FIELD INSPECTION REPORT

Project Name:	Mountain Valley Pipeline	Inspector:	Matthew Grant
Inspection Date:	Tuesday, March 9, 2021	Project Contact:	Brian Clauto
Spread H: Montgomery	ST12544+06-12518+00	Weather:	Dry

Figure 6: Designated crossing S-EF19, ECD's are in place.

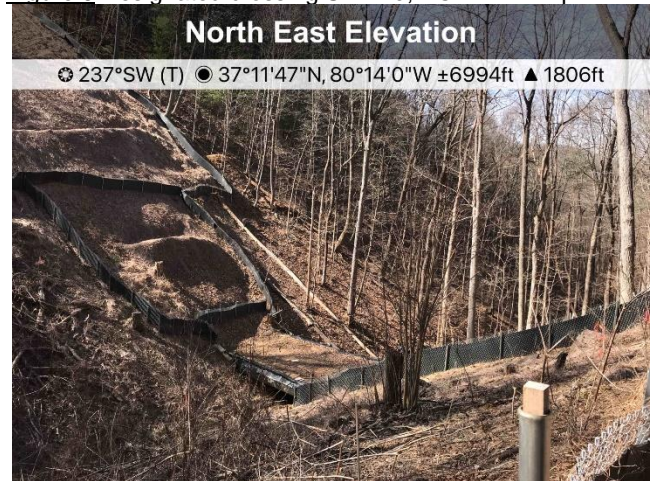
- Comments: Inspected the following resources: S-EF19
- ECD's were in place and functioning at the designated crossing.
